ADDENDUM #06

INVITATION TO BID #01

ALTERATIONS TO
ACES at CHASE
565 CHASE PARKWAY, WATERBURY, CT
STATE PROJECT NO. 244-0044 MAG
DECEMBER 11, 2025

JANUARY 20, 2026

2 BASEMENT LEVEL FLOOR PLAN

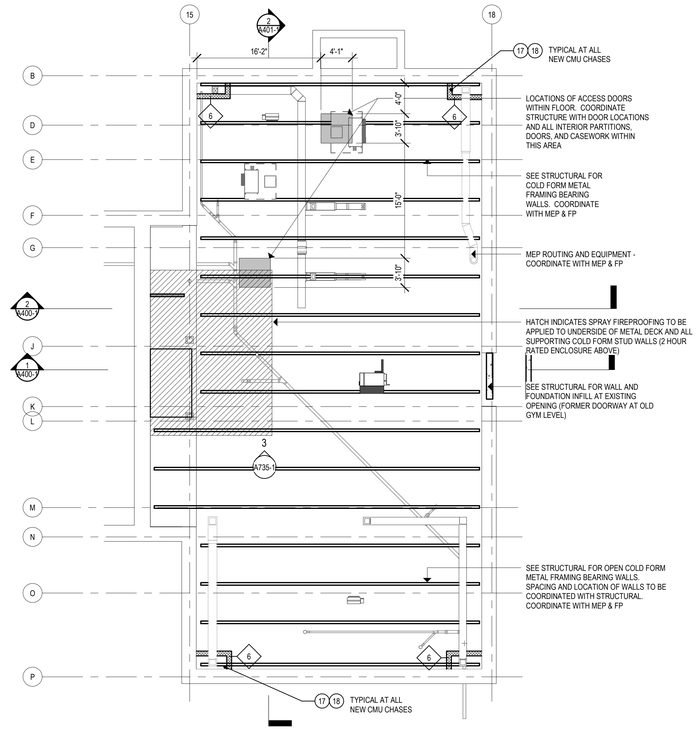
- DRAWING A110-1, BUILDING 1 – BASEMENT LEVEL & CRAWL SPACE FLOOR PLANS has been deleted in its entirety. A new DRAWING A110-1 has been added and is attached as part of this bulletin.* *(Per RFI #126)*

Drawing Title:
BUILDING 2 - LOWER LEVEL FLOOR PLAN PART A

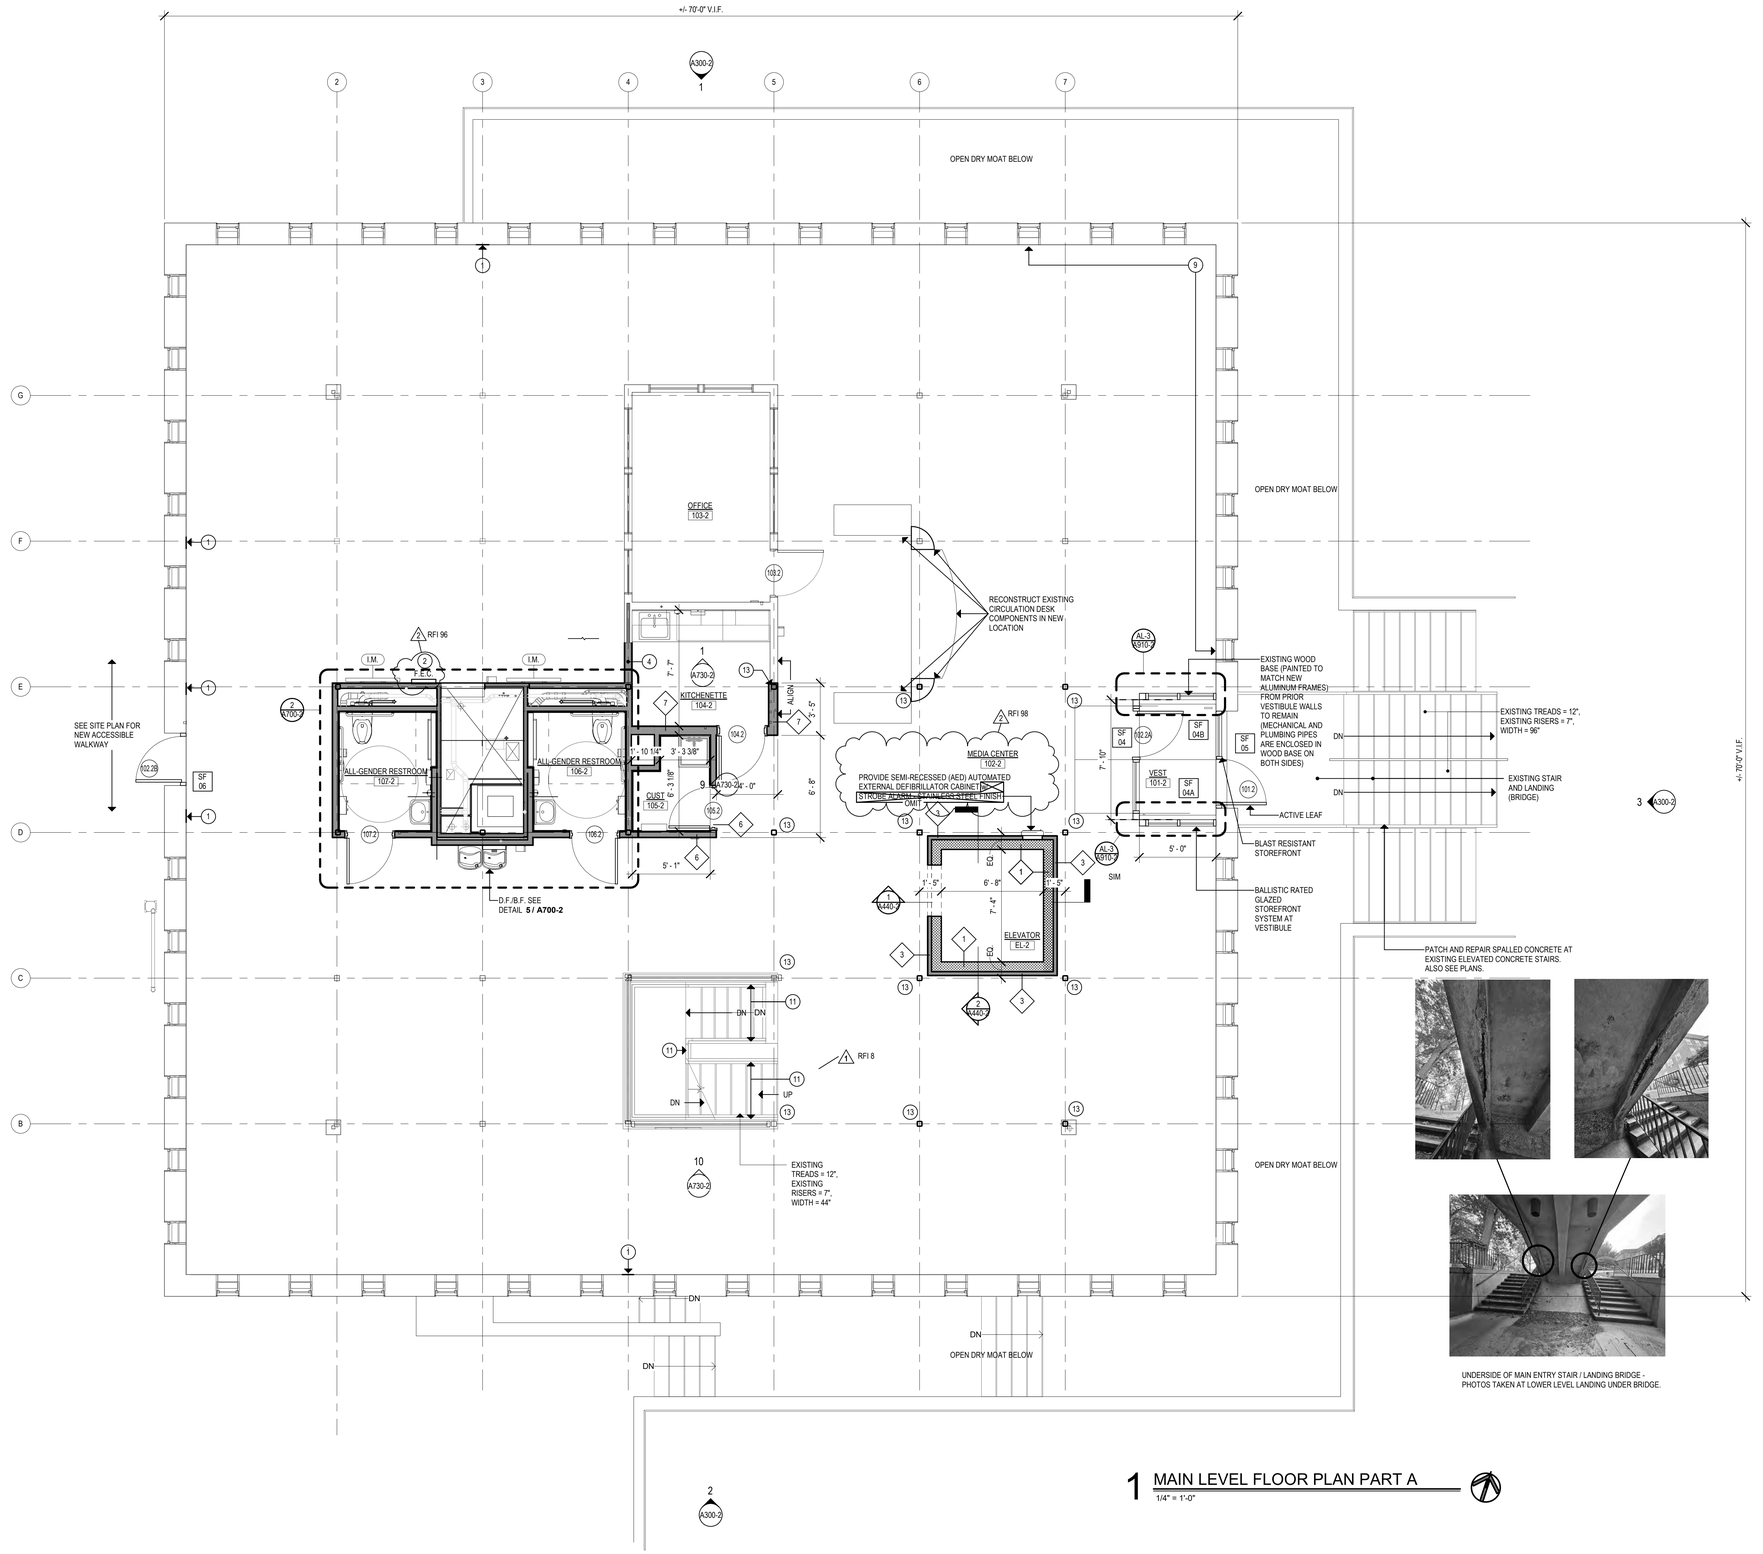
RFI 96

1 FIRST FLOOR PLAN - PART 'A'
1/8" = 1'-0"

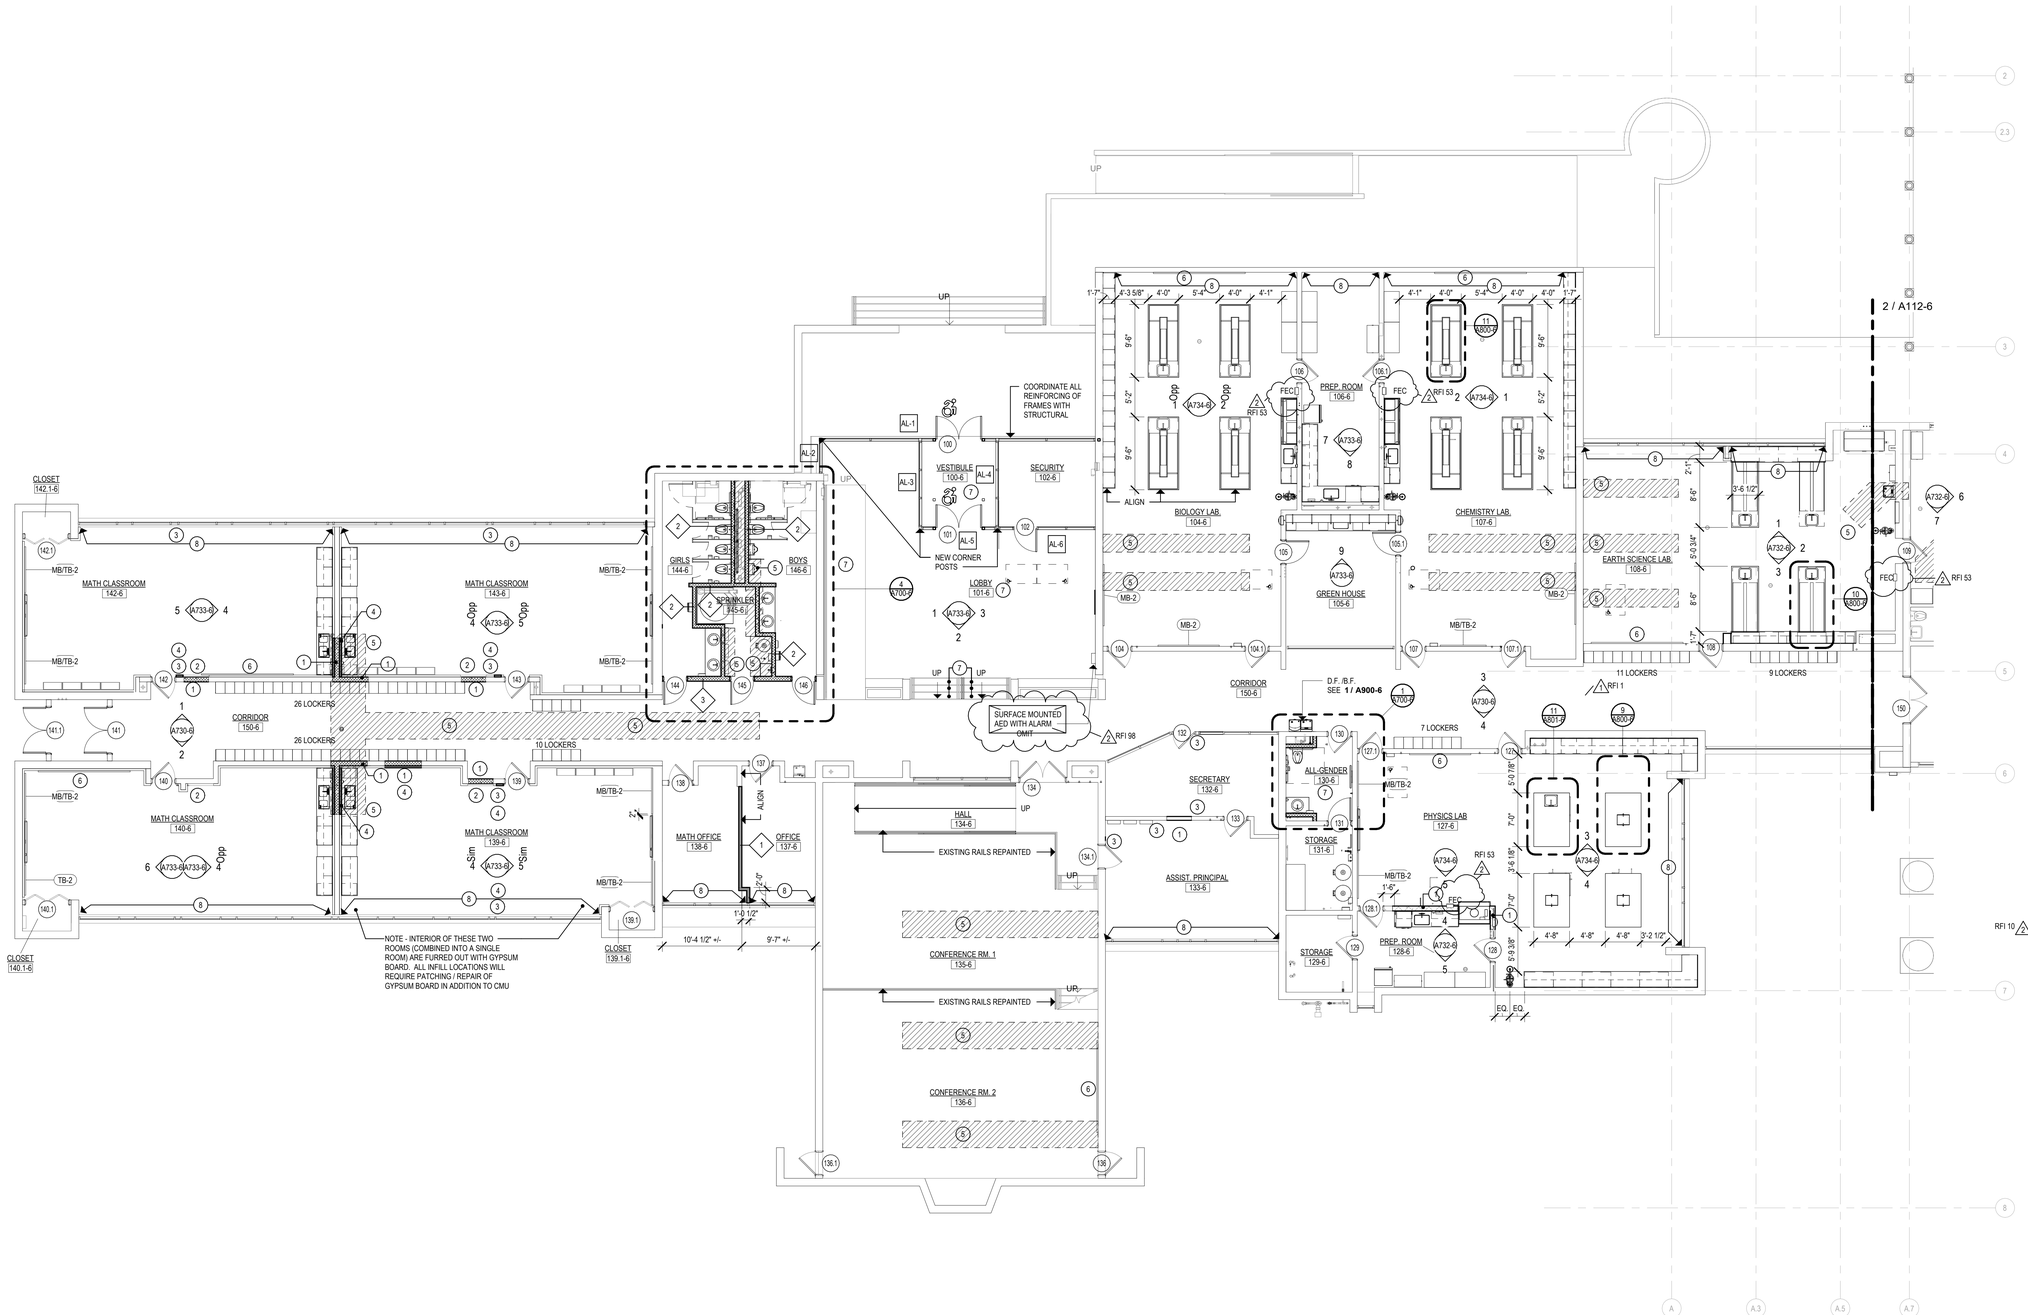
- DRAWING A110-5, BUILDING 5 – MAIN LEVEL FLOOR PLAN has been deleted in its entirety. A new DRAWING A110-5 has been added and is attached as part of this bulletin.* *(Per RFIs #8-5, #10-5, #53 & #98)*

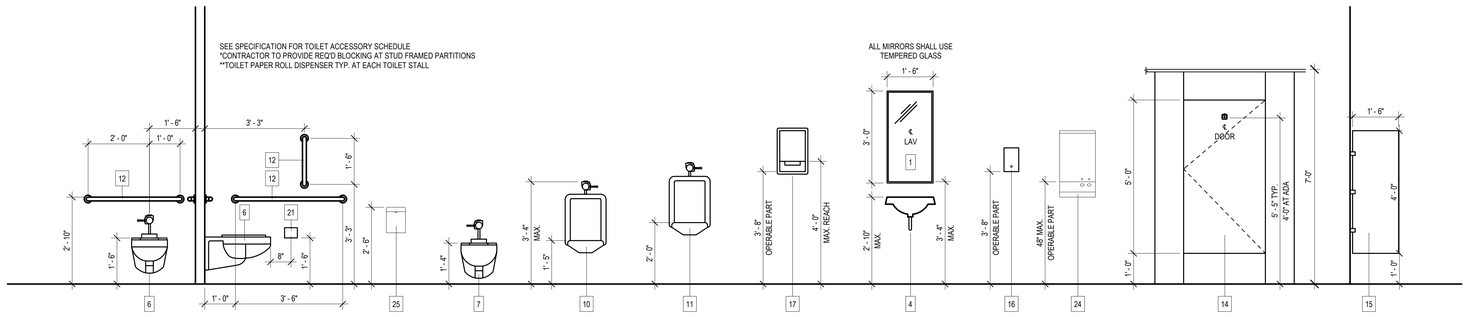
RFI 98
